Our Ref: 80216045-CV1B-RP-001:AL  
Contact: Robert Lewis

## **MARRICKVILLE METRO S75W PROPOSED MODIFICATION RESPONSE TO SUBMISSIONS**

APPENDIX F: EDINBURGH ROAD/ MURRAY ROAD PEDESTRIAN SIGHT DISTANCES

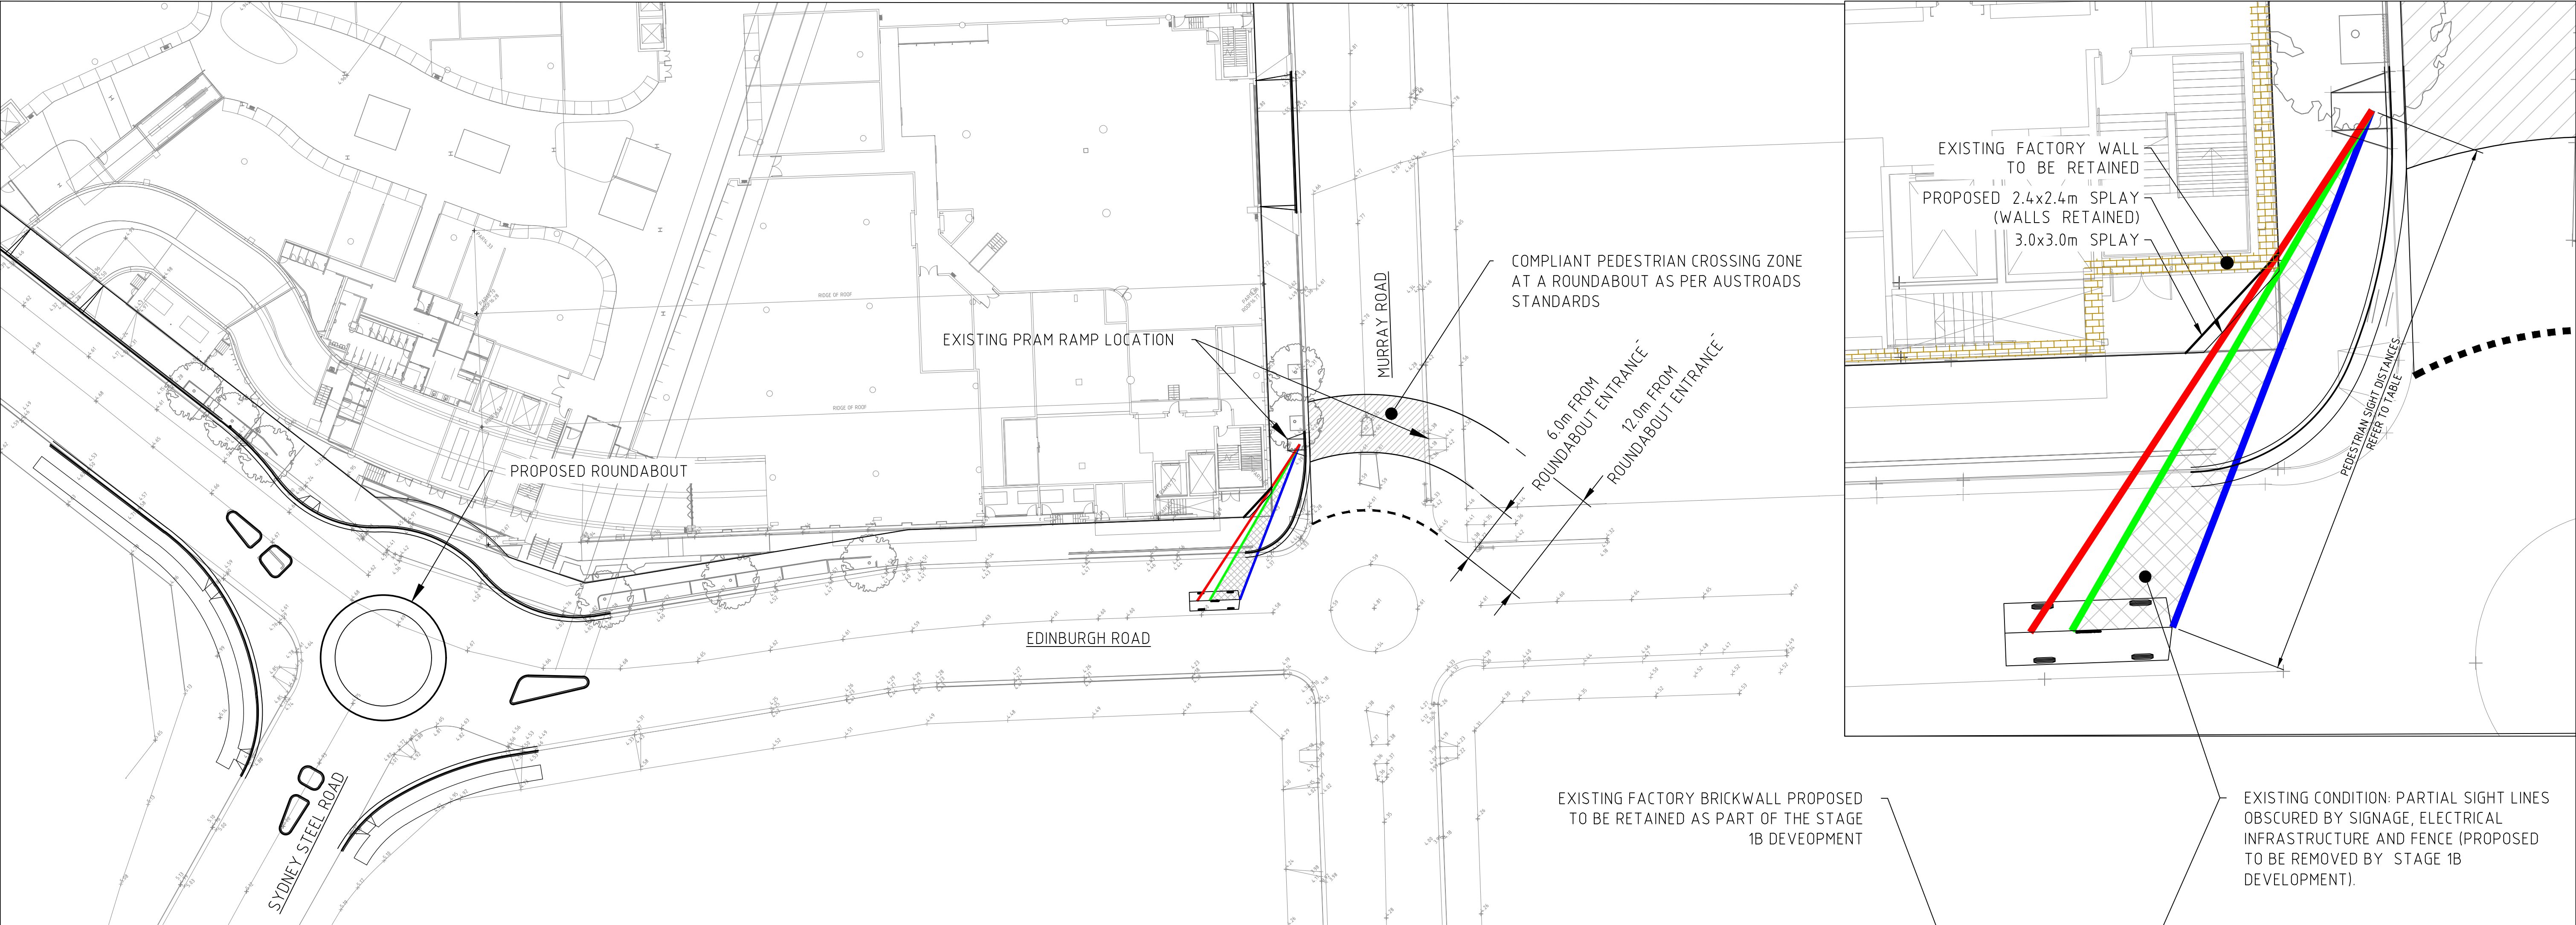
*'3m x 3m splay corners are required on junctions of Smidmore/ Murray, Edinburgh/ Murray, Edinburgh/ Smidmore'*

The existing pram ramp on Murray Road is compliant with the relevant Austroads standards with respect to pedestrian safety at roundabouts (refer to **Appendix F**).

However, the existing sight lines are partly obscured by electrical infrastructure, signage and fencing at the corner of Edinburgh/ Murray. This infrastructure is proposed to be removed to provide a 3m footpath as part of the Stage 1B development. These works will result in an improvement to sight lines compared to the existing case (as shown in **Appendix F**). As such, the proposed 2.4 x 2.4m splay and associated works improves the existing pedestrian sight lines whilst enabling the retention of the existing factory brickwork walls. The typical 3.0 x 3.0m splay provides the optimal safety outcome for pedestrian sight lines. Compared to a 3.0 x 3.0m splay, the proposed 2.4 x 2.4m splay provides an outcome with negligible difference in sight lines (700mm or a 4% reduction in sight distance). Refer to **Appendix F** for the pedestrian sight distance calculations and further technical commentary on the Edinburgh/ Murray intersection.

The proposed 2.4 x 2.4m splay complies with Austroads standards for vehicles and pedestrian sight lines whilst providing a sufficient footpath width for pedestrian access. It is the maximum possible splay dimension achievable whilst retaining the existing factory brickwork walls, which is an important feature of the Marrickville Metro Stage 1B design. On the basis that we believe we have satisfied the underlying principles behind Inner West council's requirement for splays with the proposed 2.4m splay, we request dispensation regarding the DCP requirement for a 3.0m splay in this instance.

CONTEXT	PEDESTRIAN SIGHT DISTANCE (m)	COMPARISON	COMPLIANCE. AUSTRoadS REQUIREMENT: 6-12m OFFSET FROM ROUNDABOUT ENTRANCE (GUIDE TO TRAFFIC MANAGEMENT - PART 6 AND GUIDE TO ROAD DESIGN - PART 4B AND 4B)
EXISTING CONDITION WITH SIGHT DISTANCES PARTLY OBSCURED BY SIGNAGE, ELECTRICAL INFRASTRUCTURE AND FENCING (SHOWN BLUE)	17.2 TO 18.7m (PARTLY OBSCURED)	EXISTING SITUATION	COMPLIANT. EXISTING PRAM RAMP AND PEDESTRIAN CROSSING ALIGNMENT IS SUFFICIENTLY OFFSET FROM THE ROUNDABOUT AS PER AUSTRoadS STANDARDS
PROPOSED 2.4x2.4m SPLAY (SHOWN IN GREEN)	18.7m (NOT OBSCURED)	SIGHT LINE IMPROVEMENT COMPARED TO THE EXISTING CASE (NOTING THE PROPOSED REMOVAL ELECTRICAL INFRASTRUCTURE).	COMPLIANT - NO PROPOSED CHANGE TO THE EXISTING COMPLIANT PRAM RAMP AND PEDESTRIAN CROSSING ALIGNMENT

3.0 x 3.0m SPLAY (SHOWN IN RED)	19.4m (NOT OBSCURED)	700mm OR 4% INCREASE IN SIGHT LINE COMPARED TO PROPOSED 2.4x2.4m SPLAY SCENARIO. VERY SMALL SIGHT LINE IMPROVEMENT ACHIEVED BY A 3X3m SPLAY	COMPLIANT - NO PROPOSED CHANGE TO THE EXISTING COMPLIANT PRAM RAMP AND PEDESTRIAN CROSSING ALIGNMENT
